Service Bulletin
No. : MZ03-059
Date: December 13, 2006

Model: CC4300 / PMD371

Subject: Incorrect operation with the Remote controller.

IC101 is this side of MAIN PCB

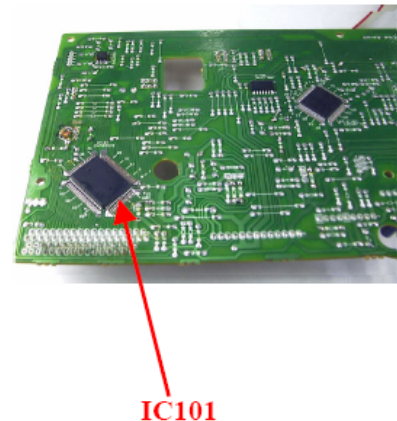
Symptom: "AMP Discrete power ON/ OFF" code is received, then the unit goes to Power ON/Standby mode. (16 12 01/16 12 02 code)

Solution: Replace MICRO PROCESSOR IC101 on the MAIN PCB.
First please check the version of IC101. The version number can be confirmed using SERVICE MODE. Refer to page 1 of the service manual.

Ref #	FORMER		NEW	
	Description	Part Number	Description	Part Number
IC101	MICRO PROCESSOR	*HU100590R	MICRO PROCESSOR	*HU100710R
